Technical Bulletin No. CFO-001

SUBJECT: Service Manual Correction

MODEL: CFO

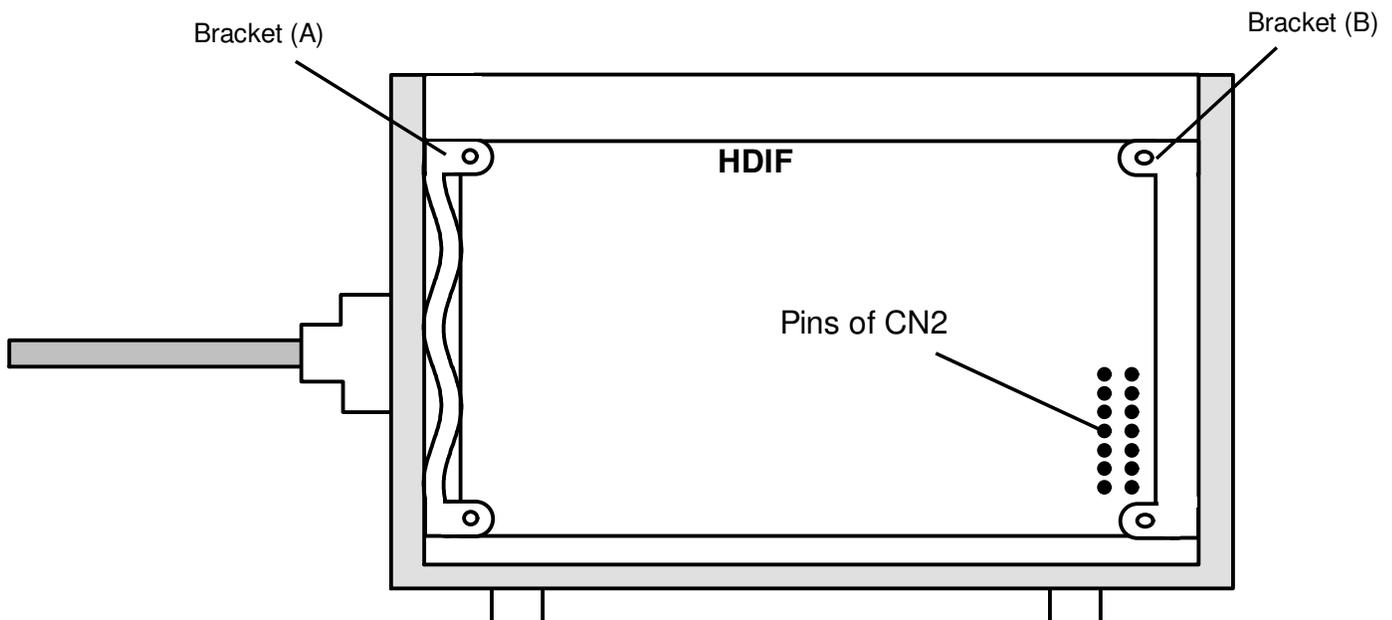
After replacing the HDIF board, the LCD may show "0%" instead of "100%" in the memory space field.

If the bracket (A) is bent, the pins of CN2 on the HDIF board may touch the bracket (B), then the HDIF board will be broken.

- When replacing the HDIF board, make sure that the bracket (A) is not bent, and the pins of CN2 on the HDIF board do not touch the bracket (B).
- For the CFO, when replacing the ROM on the HDIF board at installation, replace the ROM after removing the PSU in accordance with the installation manual. Do not remove the HDIF board.

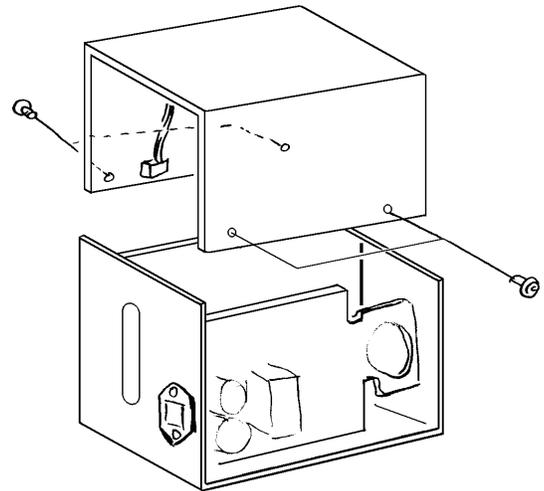
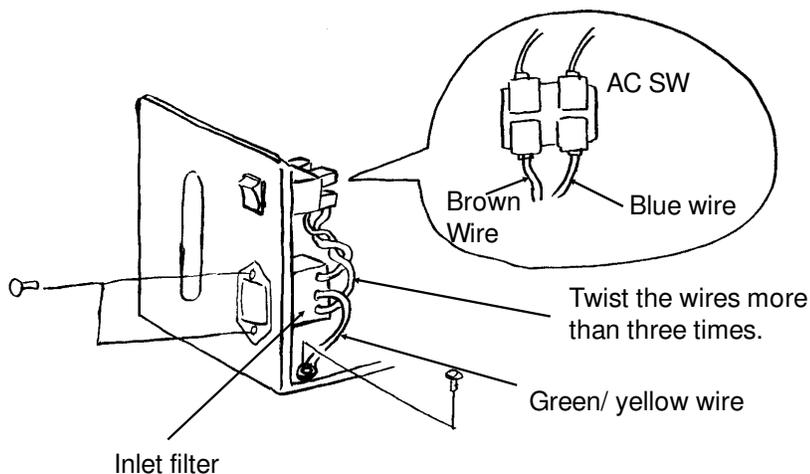
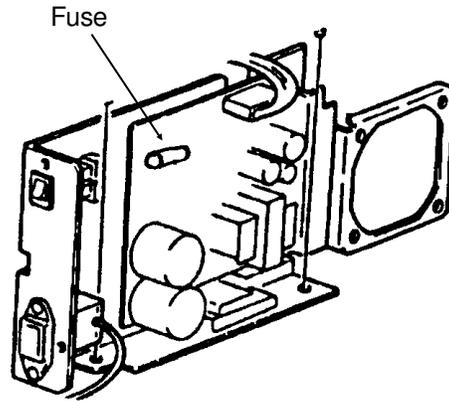
At installation in Sweden, the following parts have to be replaced to meet the Swedish safety regulations.

1. Inlet filter (H044 8202B) x 1

2. Fuse (215 series 250V/ 2A) x 1

1. Remove the hard disk cover (screw: M3 x 4)

2. Replace the inlet filter (Screw: M3 x 2, M4 x 1).

3. Replace the fuse on the PSU of the hard disk.

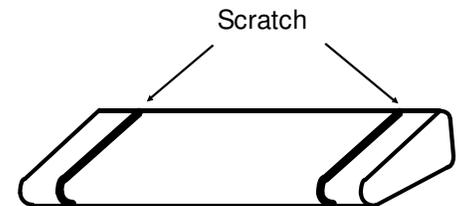
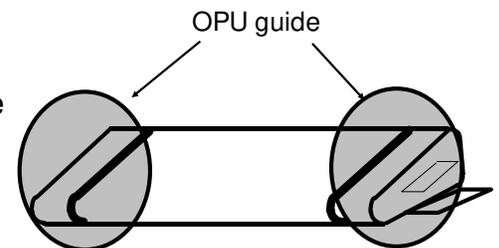
The OPU may be damaged when using the machine, as shown below. However, there is no problem on the printed image.

1. Both sides of the development roller may touch the metal blade on the development roller. By this, the shaved corpuscles may get in the space between the OPU belt and the development roller, the both sides of the OPU belt may be damaged.
2. The position of the OPU guide may be changed for some reason, then the OPU belt may touch the plastic pins on the development unit.

1. If the above problem occurs, do not replace the OPU, because, there will be no problem on the printed image, in the lifetime of the OPU.
2. Do not adjust and change the position of the OPU guide.

Fig. 3

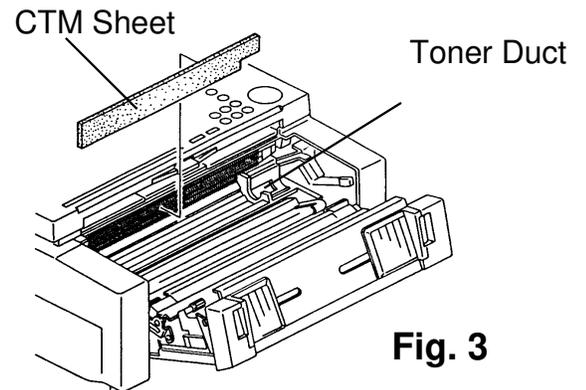
- (1) Open the front cover, then cover the OPC belt with a piece of paper (do not touch the belt surface by hand).
- (2) Attach the CTM sheet. (Fig. 3)

Fig. 4

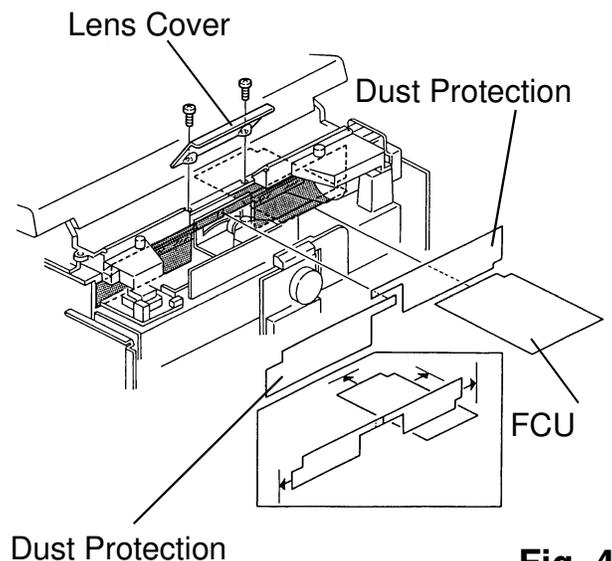
- (1) Remove the rear/ left/ right/ lens covers.
- (2) Insert the FCU sheet under the mirrors, then attach the sheet to the right side and interior of the ADF base. (Fig. 4)

- (1) Attach the dust protection sheet 1 to the left side of the scanner and the upper side of the shading plate. (Fig. 4)
- (2) Attach the dust protection sheet 2 to the right side of the scanner and the upper side of the shading plate. (Fig. 4)

Ground Wire of the LDUNI Cover

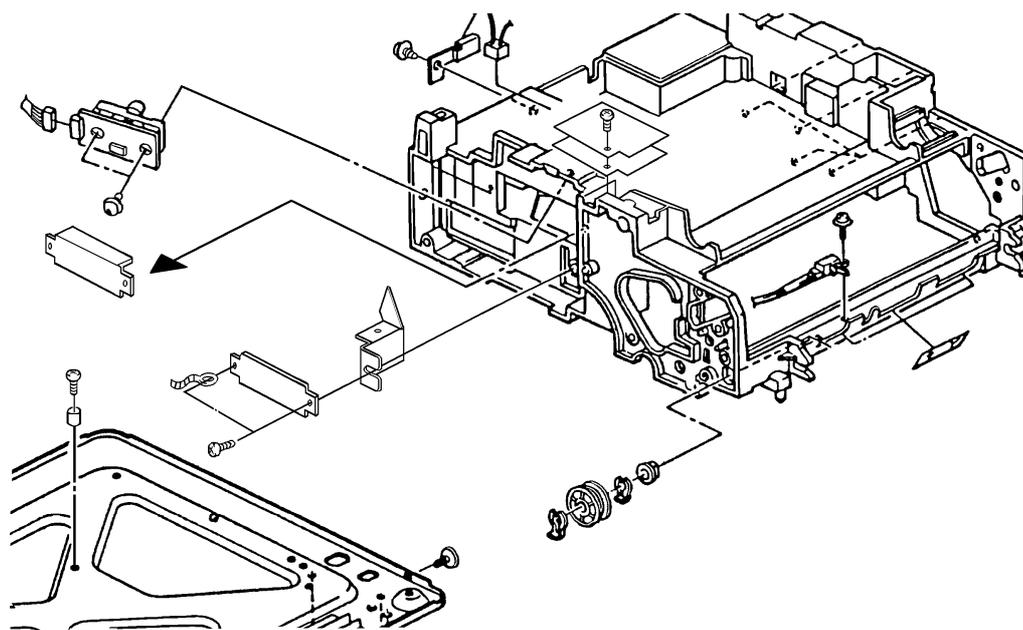
For LD-UNIT, the covers and ground wire have been added.

2. ISDN Cable (H0825700)

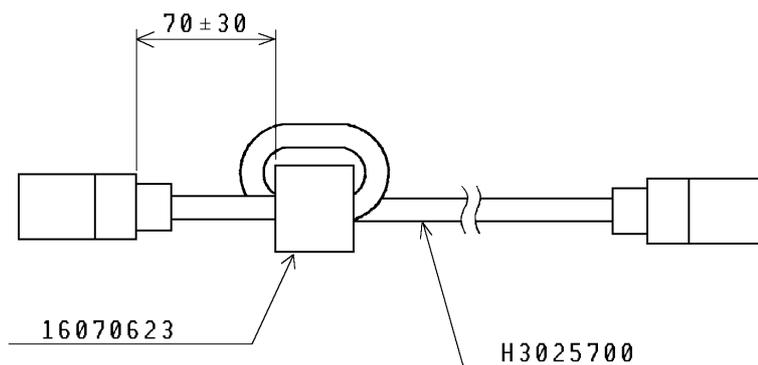
- A filter (magnet core) has been added on the ISDN Cable.

**3. Ground Wire (H0825125)**

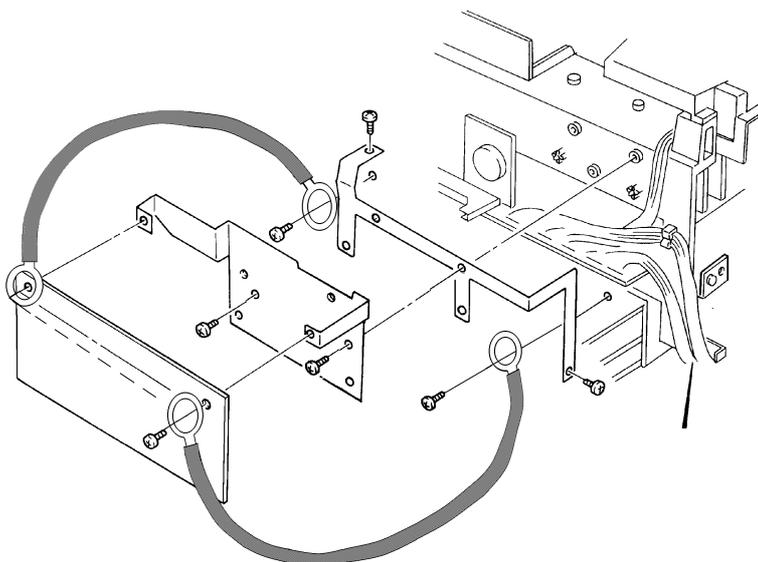
- Two ground wires have been added between the C1G4 Cord and the Bracket.

Hot Roller Kit:

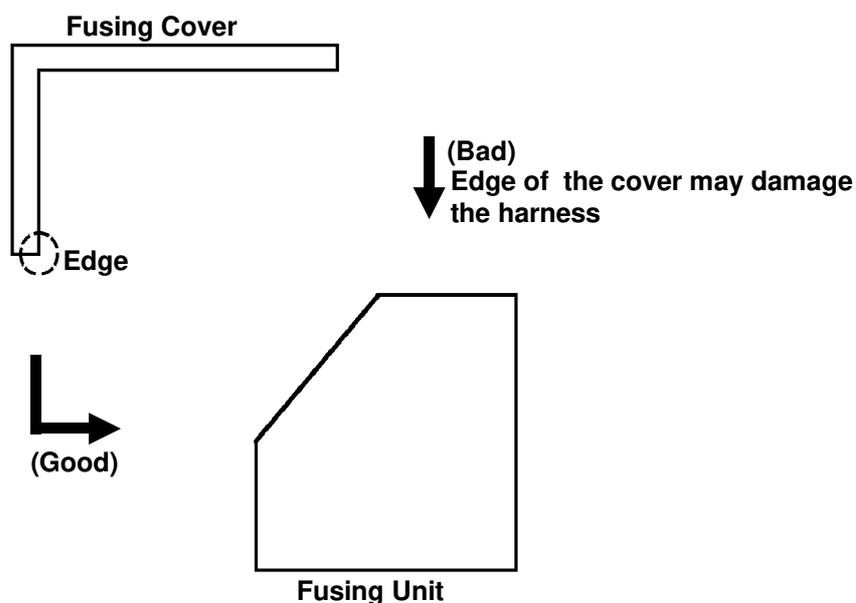
The hot rollers shipped from the SPC in Japan will be replaced by the Hot Roller Kit in July.

This kit will be comprised of the following: Hot Roller, Cleaning Pad, Thermistor, Thermistor Bracket, Screw, Strippers (2), Stripper Springs (2) and Installation Sheet. The individual Hot Roller will be no longer available. The Cleaning Pad will continue to be a Service Part.

Ricoh recommends change of the above modified parts and Cleaning Pad when the failed Hot Roller is replaced with the new one.

Installation Procedure for the Thermistor

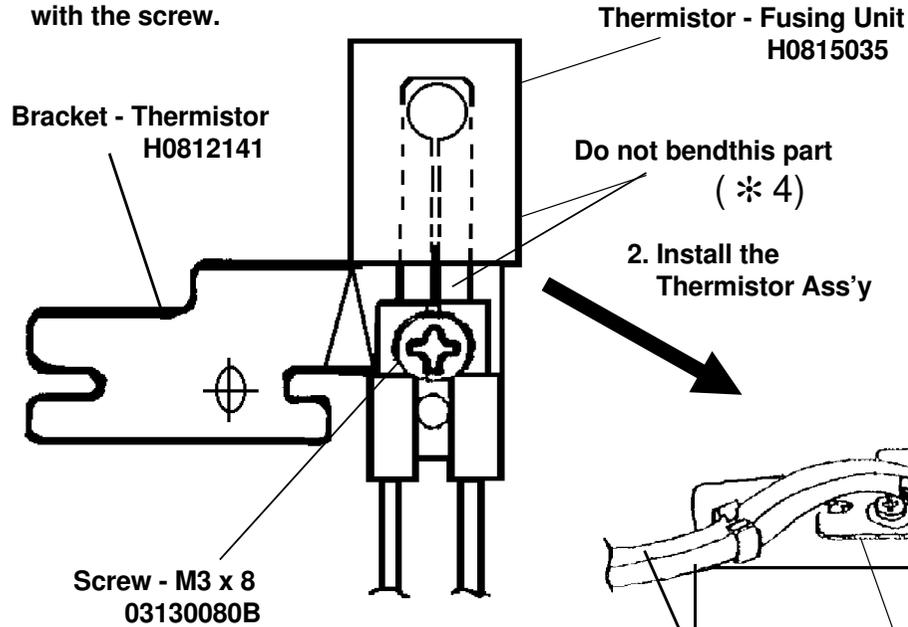
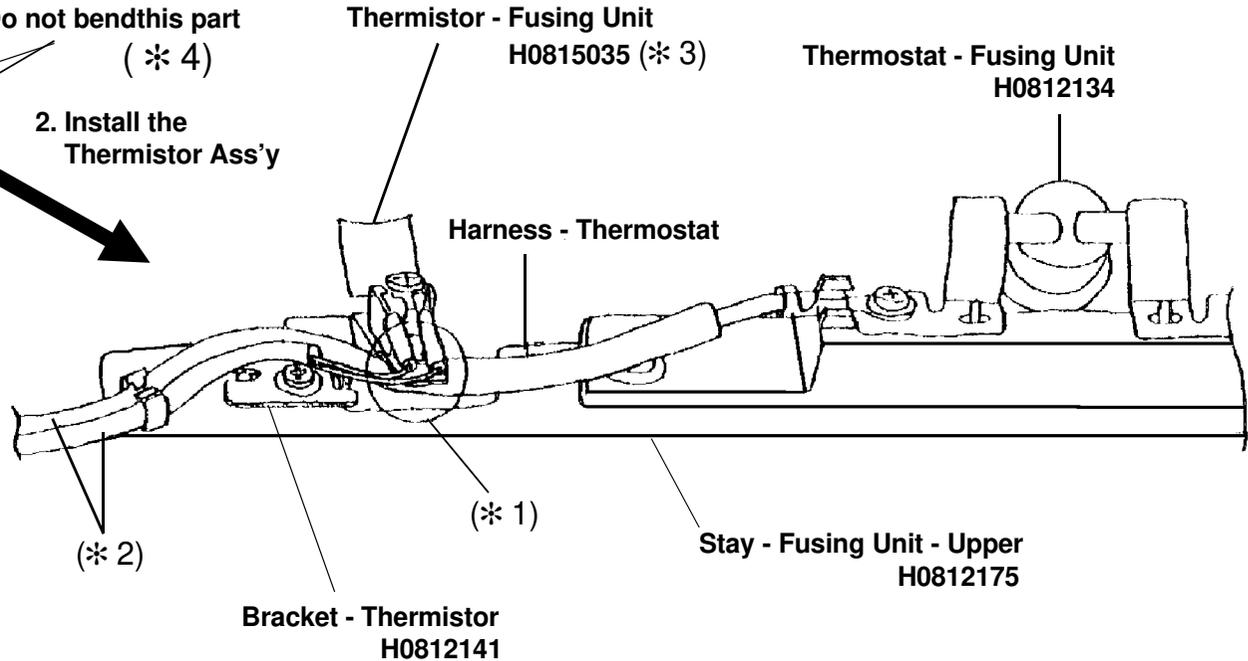
(A): Please refer to the following instructions and fix the cover to the fusing unit and check that the harness is not pinched before installing the fusing unit in the machine.

If the metal wire of the harness contacts the thermistor bracket, a no power condition may occur. Please check the thermistor harness if this occurs.

1. Assemble the thermistor and the bracket with the screw.

Do not bend this part (* 4)

2. Install the Thermistor Ass'y

- Note: * 1 Place the thermostat harness under the part of the bracket.
- * 2 Do not cross the thermostat harness and the thermistor harness.
- * 3 Push the thermistor head (sensor) gently against the hot roller with a finger to make sure that the thermistor head touches the hot roller surface. Do not push it strongly.
- * 4 Do not bend the thermistor neck (spring plate) when installing or cleaning it .
If the thermistor is bent, replace it.
